Permit No. PZ23-00005 (SUB)

**PZ23-00005 (SUB) Canyon Vista Subdivision Preliminary Plat
Consolidated Comments/Responses –May 8, 2024**

Project Name: Canyon Vista Subdivision Preliminary Plat Application
Located within the City of Sedona, Coconino County, Arizona. More specifically described as Assessor's Parcel Number 401-20-027G: Northwest ¼ of Northeast ¼ of Section 18, Township 17 North, Range 6 East of the Gila and Salt River Meridian.
Applicant: Sefton Engineering Consultants
Owner: CV Development Sedona, Inc. c/o William M. Heyer, President

Section 5.4.E(1)b.3 Driveways and Access

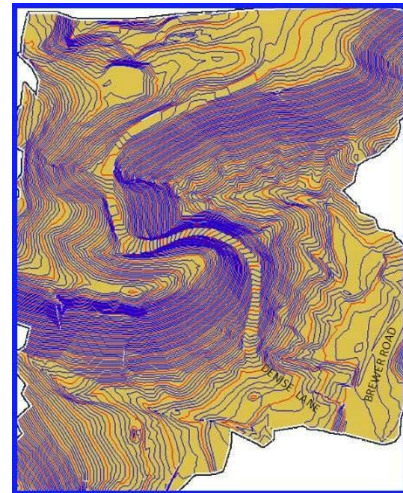
Shared driveways are provided to the maximum extent feasible to minimize the number of access points to streets (except for driveways within residential subdivisions or along private residential streets).

In compliance. We have made some changes to the driveways in the area. Lots 4 and 5 will now share a driveway, so we no longer need a second connection to Brewer Road. Additionally, to reduce the impact on the neighbor to the southeast, we have consolidated the driveways for Lots 1, 2, and 3 with a shared driveway.
